Addendum No. 01

Subject: Andrew J. Morrison Elementary School – Fire Alarm System Replacement
SDP Contract No. B-009 (C) of 2017/18

This Addendum 01, dated January 30, 2018 shall modify and become part of the Contract Documents for the work of this project. Any items not mentioned herein, or affected by, shall be performed strictly in accordance with the original documents.

DRAWING NO.
E100B

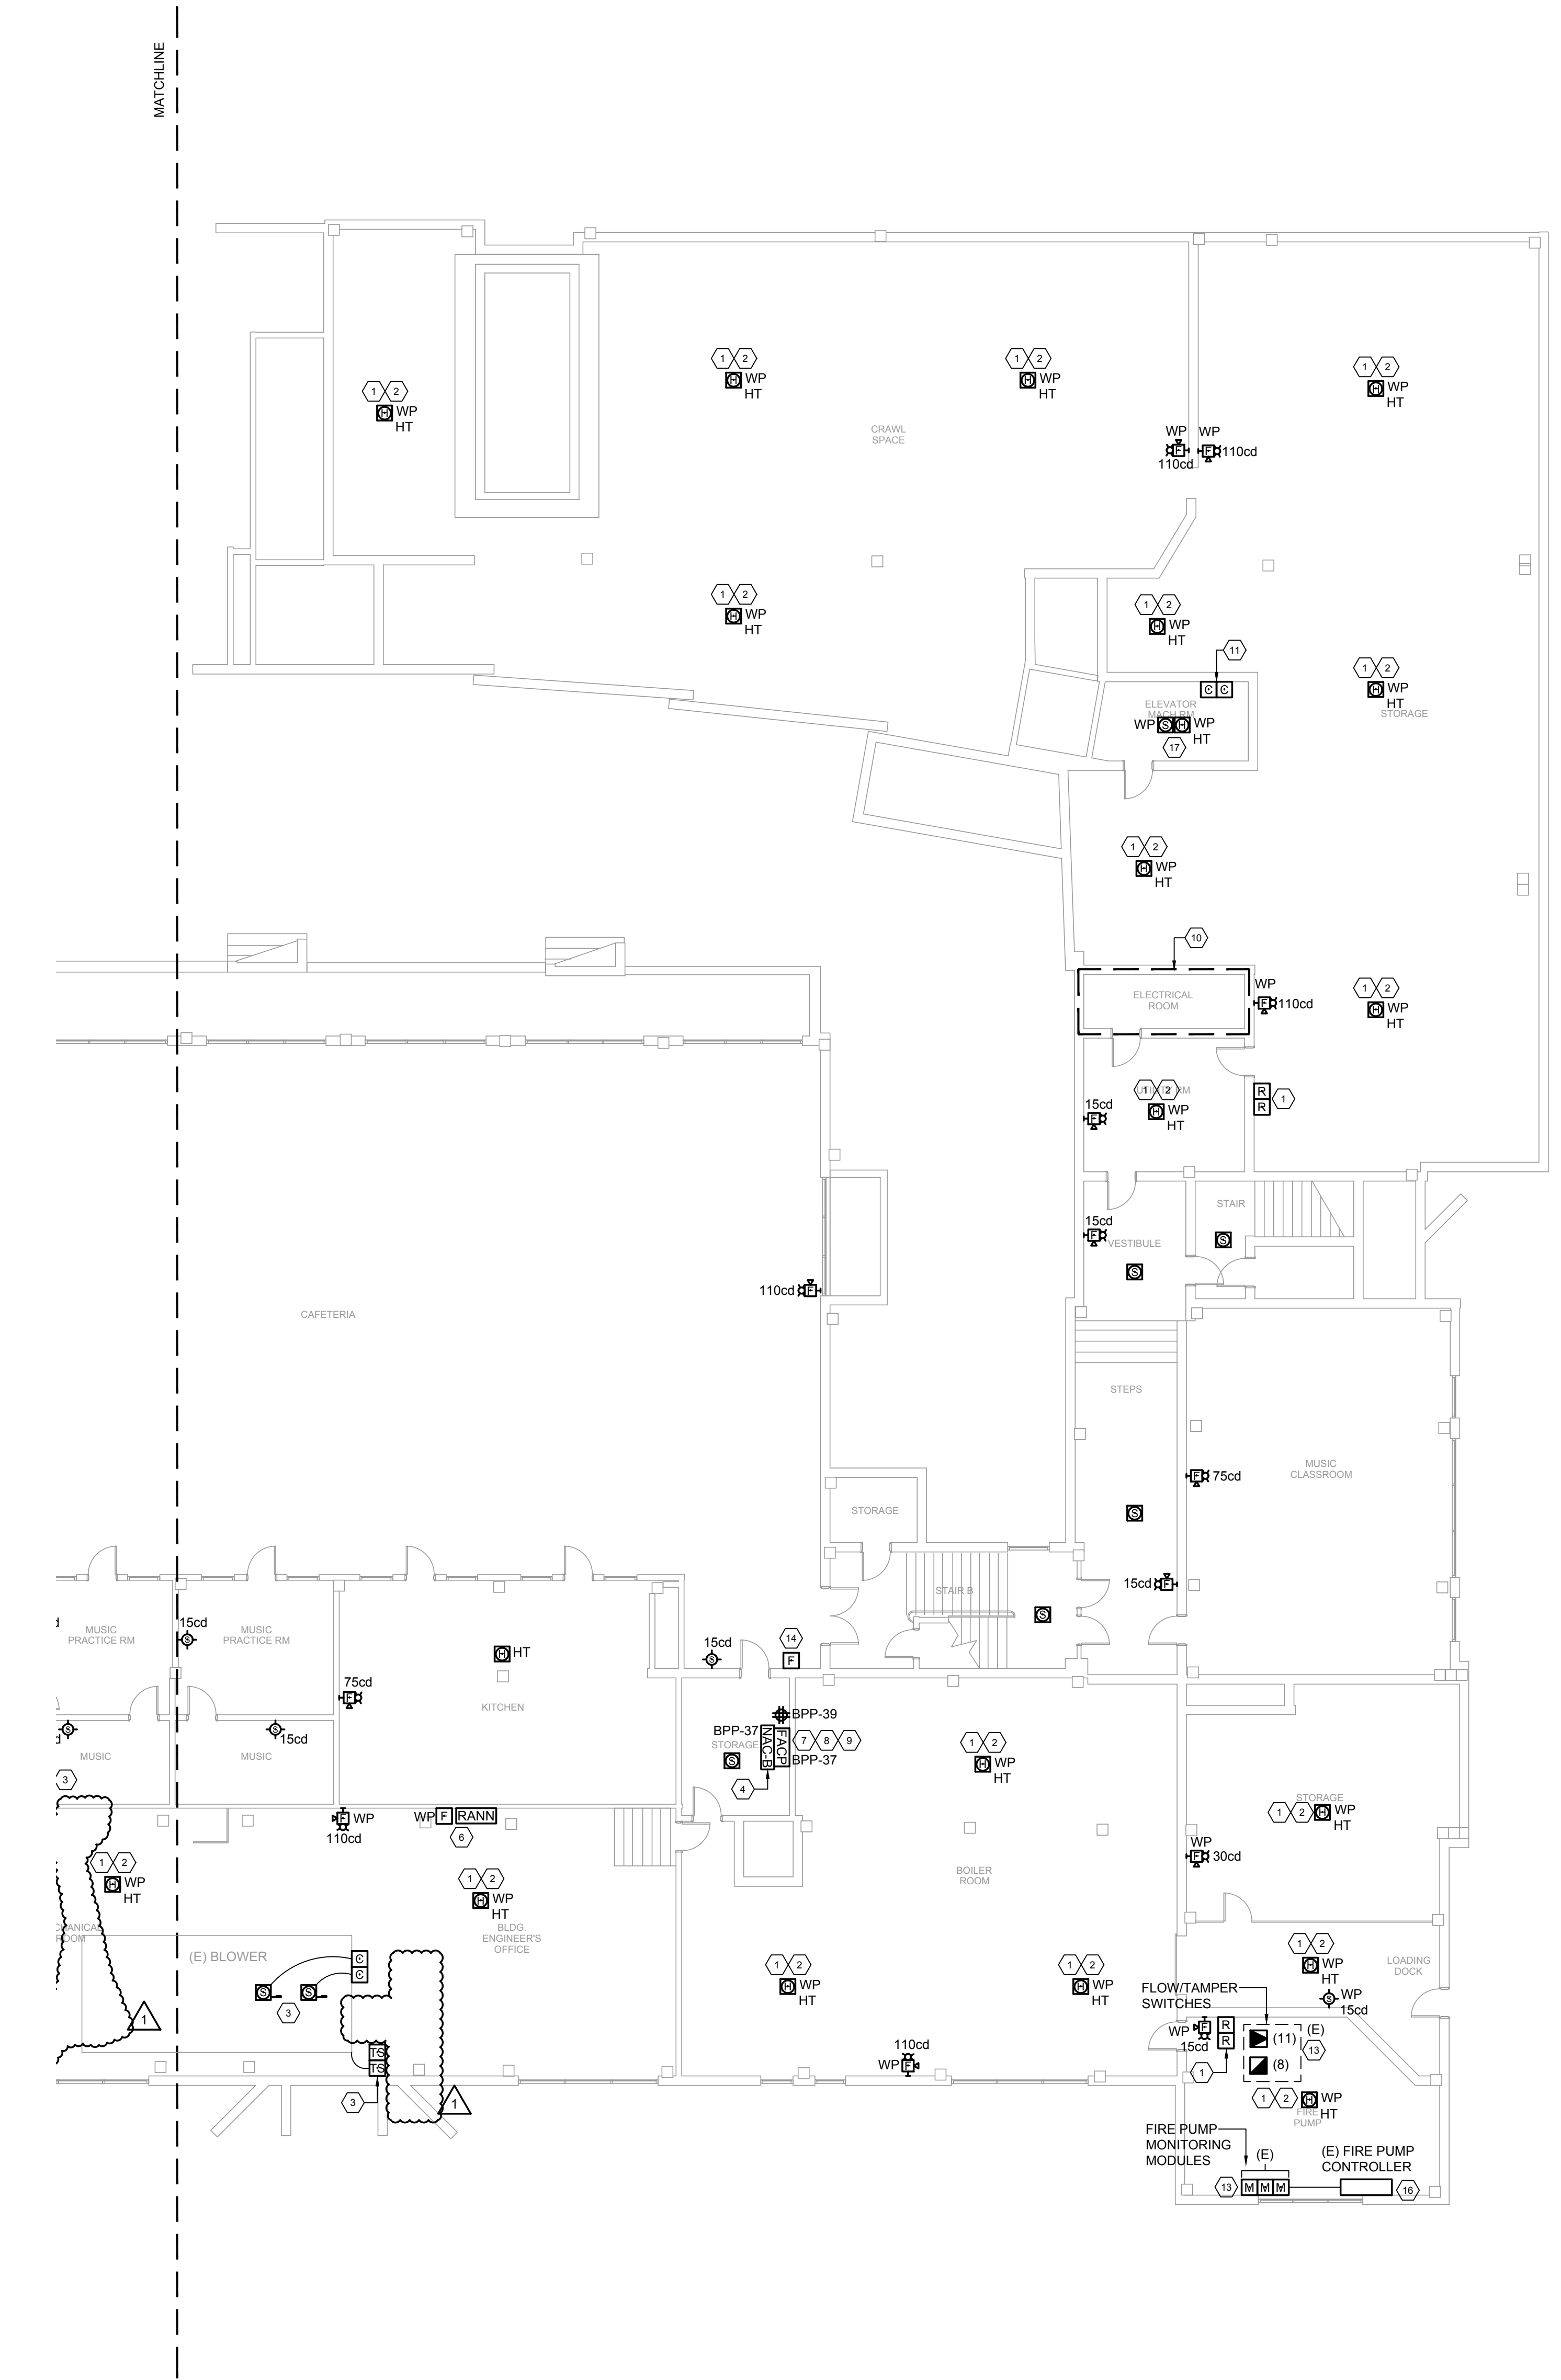
Drawing E100B – Revised Keynote #8, removed requirement for (2) copper telephone lines to FACP.

Removed Keynote #5 and #12. Removed scope of work for AHU motor replacement.
